Access Compliance Report Public Rights-of-Way (Curb Ramps)

Intersection ID: 10040992	Main Street: WALTON_RD	Cross Street: CHELVESTON_DR	Location: E
ADA ID: 6BEB89E7D8B2	Ramp Type: Directional1	Initial Pass/Fail: Pass	Overall Compliance: No Severity Score: 0.25

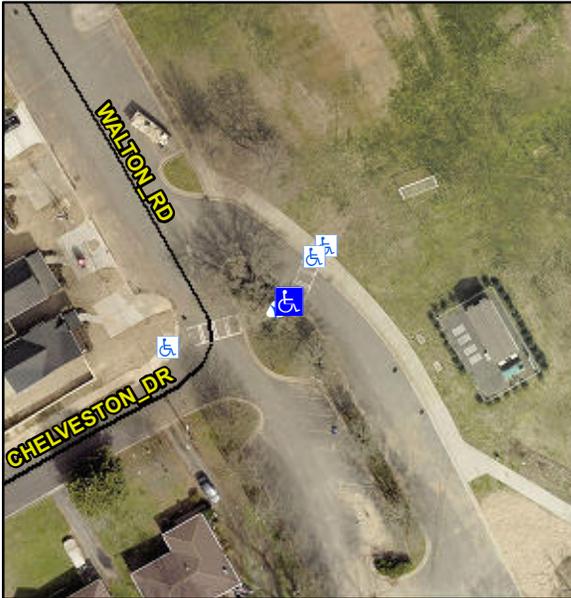
Possible Solutions:
Remove & Replace Landing.
Remove & Replace Gutter.

Surveyor Notes:
LOCATED ON ISLAND

PROW/ADA:
**R304.2.2-Perp, R304.3.2-Para,
 R304.5.3**
